**Review of Landscape & Visual Impact  
Assessment by William James Landscape  
Architect (May 2021)**

**FLAT ROCKS WIND FARM**  
**REVIEW OF LANDSCAPE AND VISUAL ASSESSMENT**  
**BASED ON REVISED ZONE OF VISUAL INFLUENCE MAPPING**

Thursday, 13 May 2021

WILLIAM JAMES LANDSCAPE ARCHITECT

Figure 6: Zone of Visual Influence of Hubs (125m high) overall - new layout

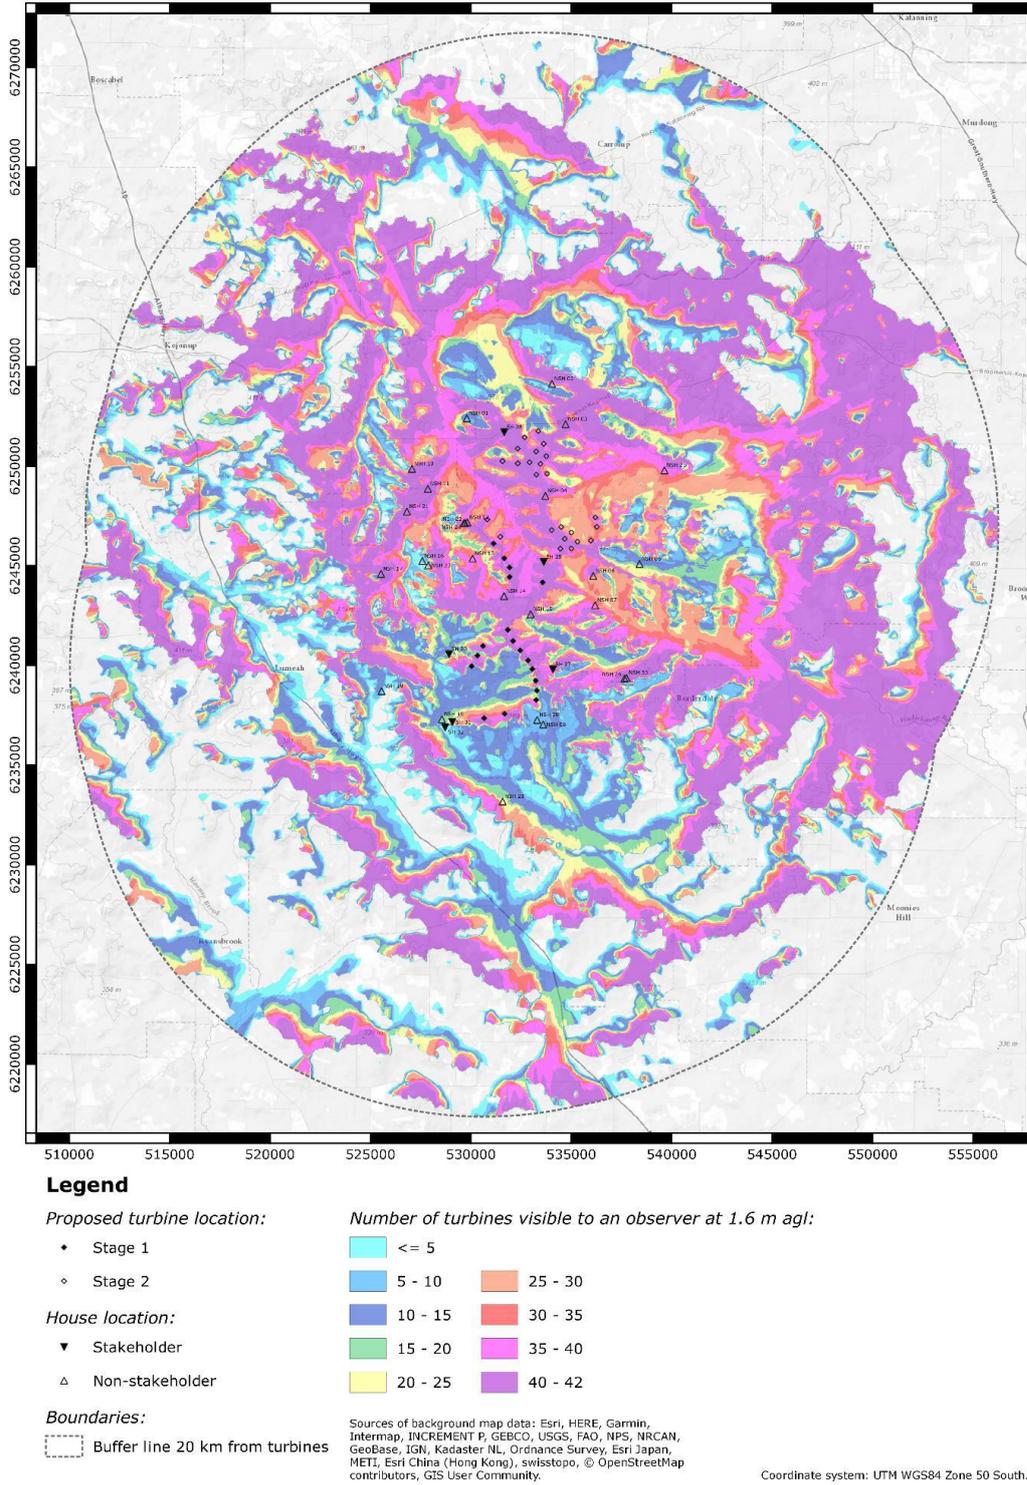
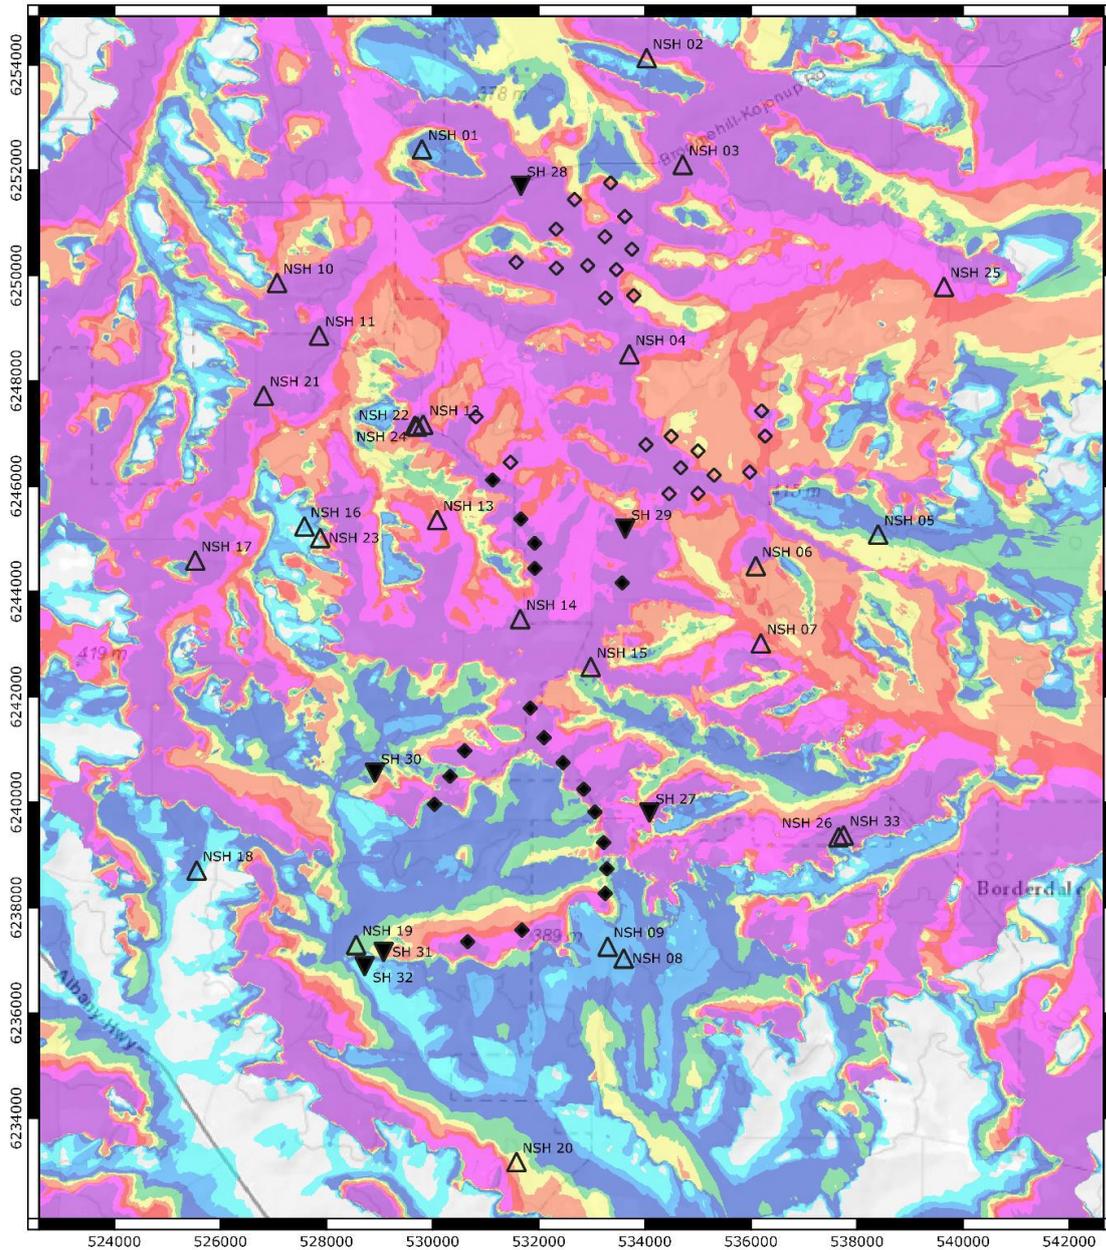
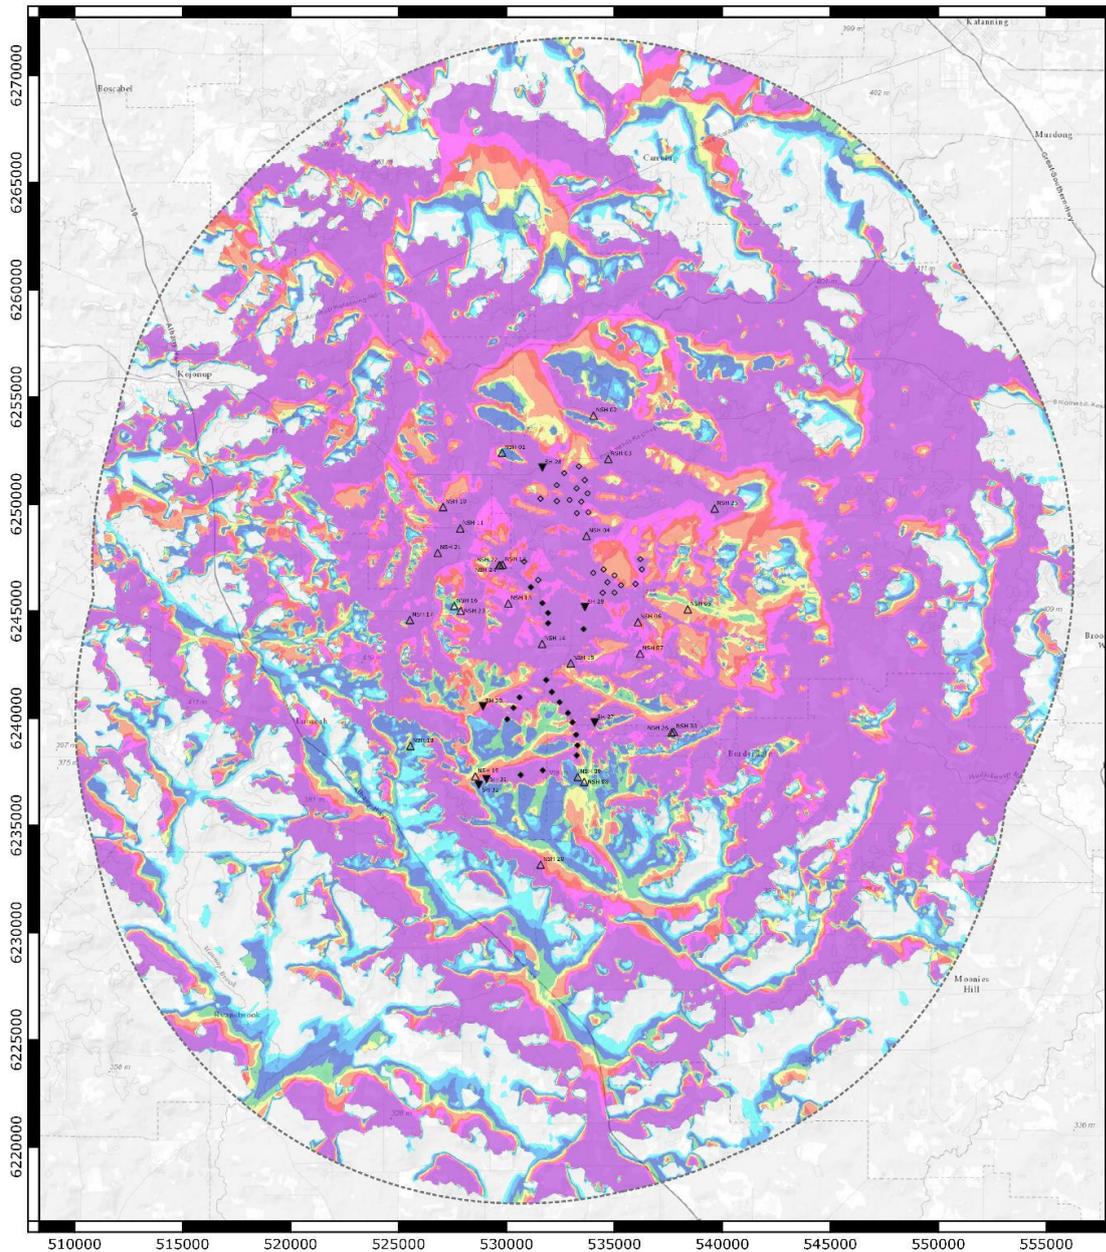
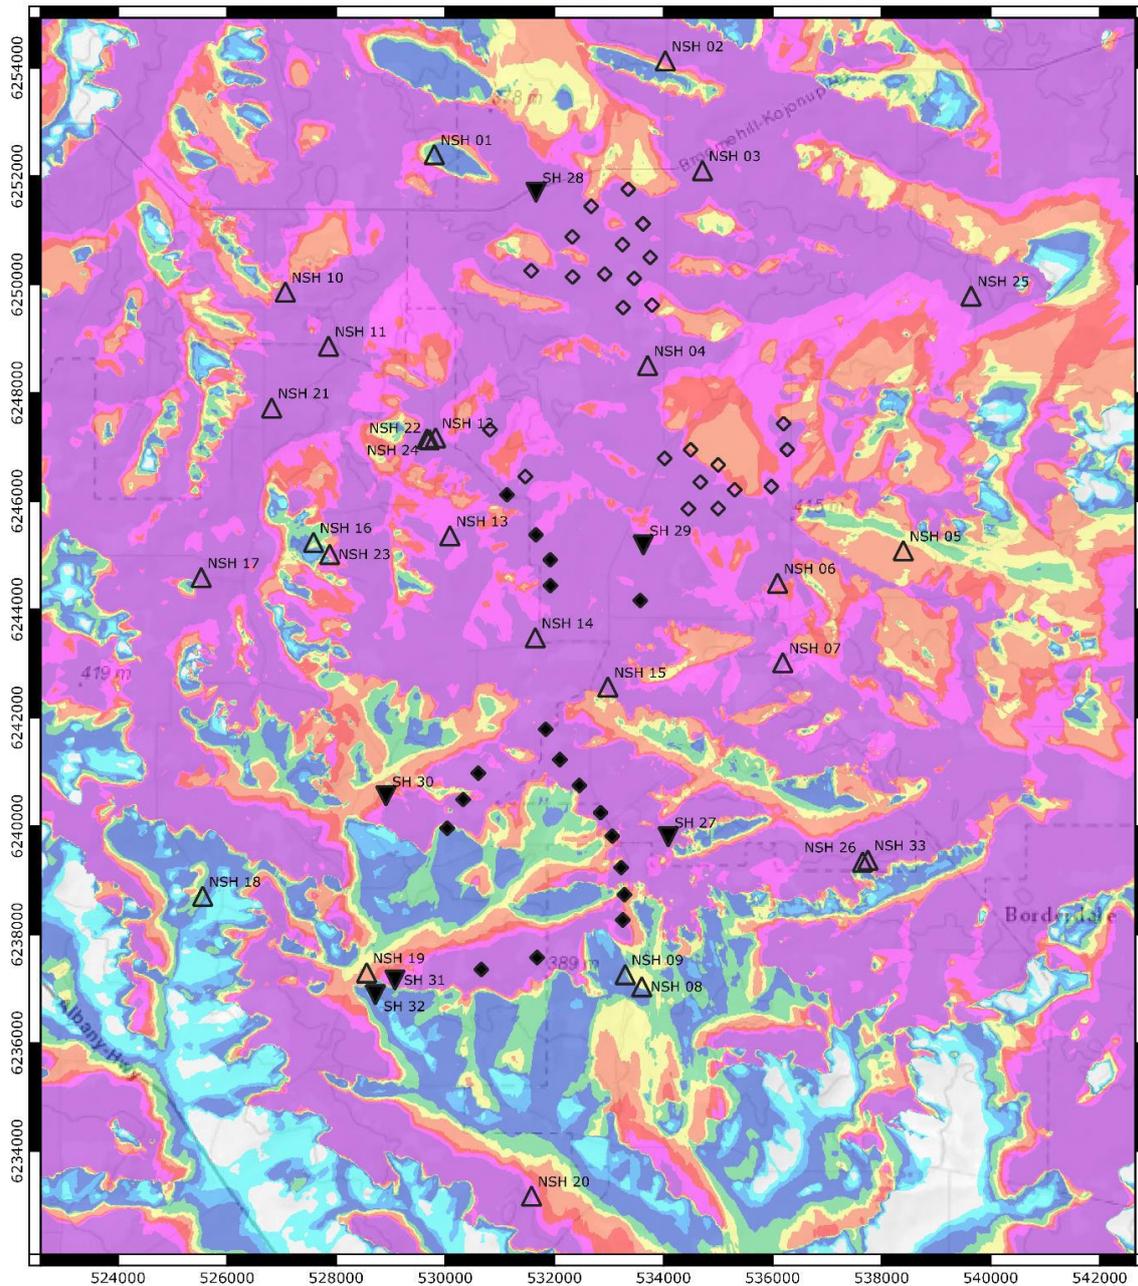
The Zone of Visual Influence (ZVI) maps of the new and original layouts are represented in Figures 4, 5, 6, 7, 8 and 9. The ZVI maps were supplied by DNV Energy Systems, the same party who provided the original and 2016 maps<sup>2</sup>. The ZVI maps are based on landform only and do not allow for intervening vegetation or structures. The ZVI analysis does not determine which hubs may be seen from where, just how many will be seen from given locations – in this case non-stakeholder and stakeholder houses.

Two maps were provided, one showing the ZVI of the turbine hubs and the other showing the ZVI of the blade tips.

This principle can be applied to dealing with specific situations. If the number of turbines close to a specific viewing location has remained relatively constant but the size has increased, it can be concluded that the potential impact will be greater. This can be remedied by relocating some of the turbines further away or by ensuring effective screening from the affected location. The specific locations where these remedies should be considered are the cluster south west of NSH 03<sup>6</sup>; the cluster north of NSH 06; and the cluster to the east of NSH 13.

- In specific situations, as discussed in Section 4, the impact of larger turbines relatively close to viewing locations, can be reduced by one of, or a combination of, the following remedies: relocating turbines or ensuring effective screening of the turbines from the impacted viewing locations<sup>7</sup>. This applies to the cluster south west of NSH 03<sup>8</sup>; the cluster north of NSH 06; and the cluster to the east of NSH 13. Of these three, only NHS 13 is relatively close to the Stage 1 turbines.
